BAY FRONT SUBDIVISION

APPLICATION NUMBER Holdover DATE November 2, 2006
APPLICANT Bay Front Subdivision
REQUEST Subdivision

DETAIL SITE PLAN

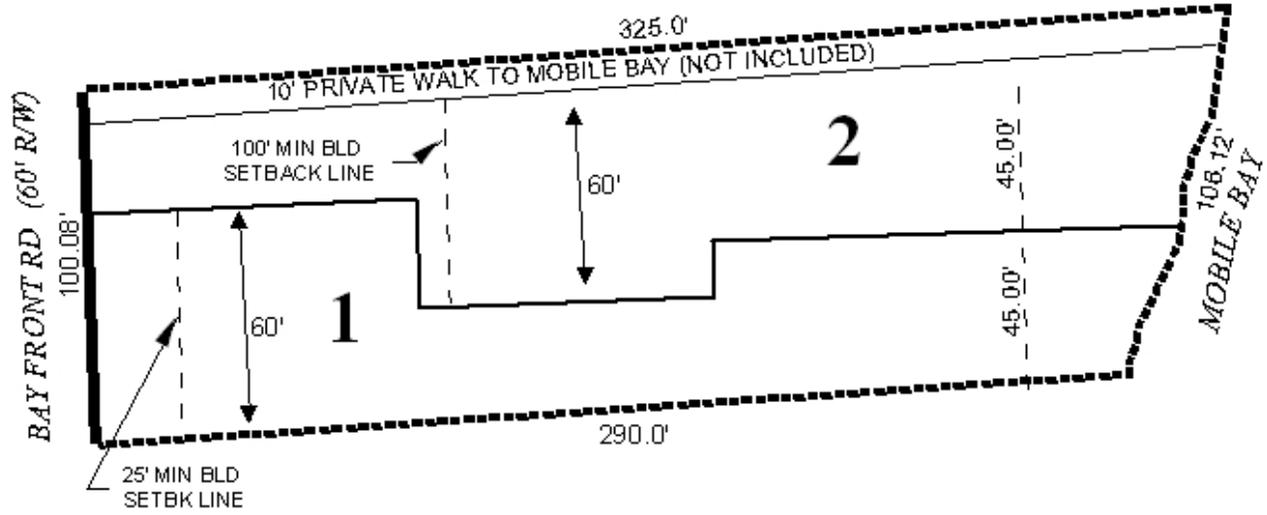
Regarding the proposed plat, the minimum area requirements would be met, but the property is peculiarly arranged in order to provide a more standard building site for each lot and to provide each lot with equal frontage on the bay. Therefore, each lot actually has a portion for building, which is 60-feet-wide at the setback, a 30-foot portion not for building, and a 45-foot waterfront portion. Technically, therefore, the plat would meet the Subdivision Requirements that a lot be 60 feet wide at the building setback line. However, a waiver of the Maximum Depth ratio (Section V.D.3) would be required based on the overall dimensions of the property. Waivers of this ratio are common for waterfront properties, and these irregularities in the lot lines would not seem to compromise the character of the surrounding area when the properties were constructed—it is unlikely that they would even be noticed. Nevertheless, subdivision of the property into additional lots should not be allowed in the future.

As the site is located entirely within the AE floodplain and is on the waterfront, it should be considered environmentally sensitive; all applicable federal, State, and local approvals would be

required prior to the issuance of permits. Finally, lot sizes should be illustrated in square feet either through labeling or the provision of a table on the final plat.

With a waiver of Section V.D.3 of the Subdivision Regulations (Maximum Depth), the plat would meet the minimum standards of the Subdivision Regulations, and is recommended for Tentative Approval, subject to the following conditions: 1) the placement of a note on the final plat that there will be no future subdivision of the property into additional lots; and 2) labeling of all lots with size in square feet, or placement of a table on the plat containing the lot size information.
